FIRE SAFETY INSPECTION REPORT

SPRING TRADE LTD

ACCORD
on Fire and Building Safety in Bangladesh

May 3, 2014

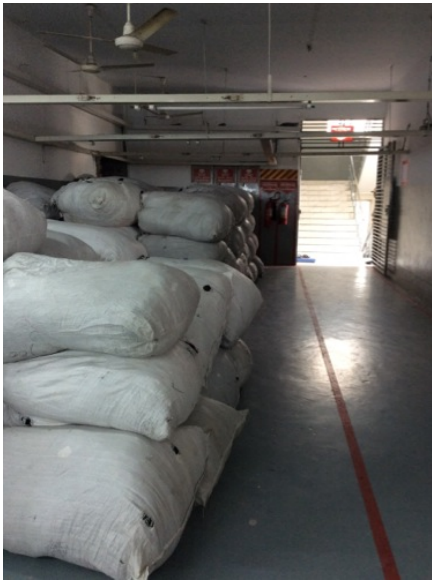
F-3	Fire Rated Construction	The generator and transformer room is not separated by fire-rated construction due to unprotected openings. Room is located at ground floor.	Separate the generator and transformer room by a minimum 2-hr fire-rated construction. Seal and/or protected all openings to maintain the required fire separations	Within 3 months
-----	-------------------------	---	---	-----------------

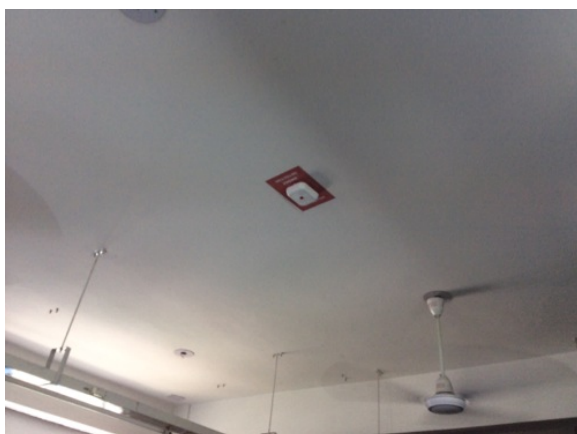
F-11	Fire Protection	The building is equipped with single-station smoke alarms. Smoke alarm activation sounds only a local alarm and does not provide automatic fire alarm notification of occupants.	Replace the single-station smoke alarms. Provide automatic smoke detection throughout the building in accordance with NFPA 72.	Within 6 months
------	-----------------	--	--	-----------------
